STATE OF OREGON
WATER RESOURCES DEPARTMENT

REQUEST FOR WRITTEN APPROVAL TO USE CONSTRUCTION METHODS NOT INCLUDED IN THE RULES AND REGULATIONS PRESCRIBING GENERAL STANDARDS FOR THE CONSTRUCTION AND MAINTENANCE OF WELLS IN OREGON

(1) Location of Well: NW 1/4 SW 1/4 of Section 22,

(2) Name and address of Landowner: Port of Morrow

(6) A diagram showing the pertinent features of the proposed well design and construction (attach additional sheet if necessary):

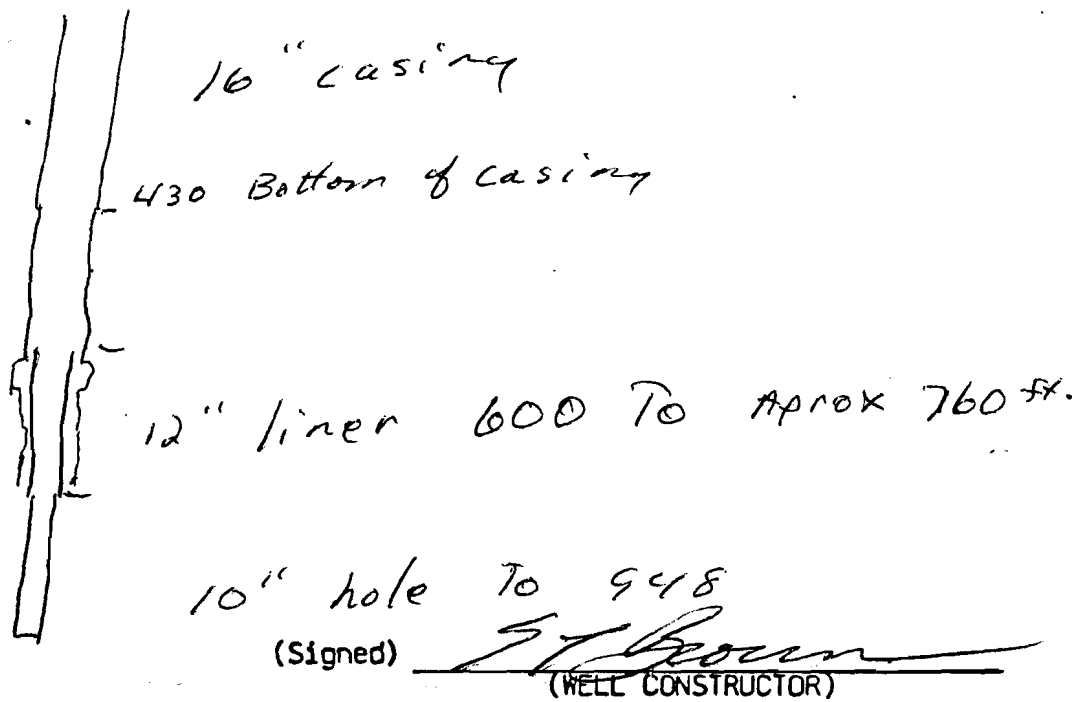
(4) The unusual conditions existing at the well site: Clay layer

at 605 ft needs a liner to

stand open

Request variance to install liner

above clay layer But not extend

up into 16" casing at 430 ft.

This would allow a 15" pump chamber

to 600 ft.

Date: 3.26.99
Approved by: Michael J. McLeod
Denied by: _____
Remarks: Liner is installed so that it can be removed.
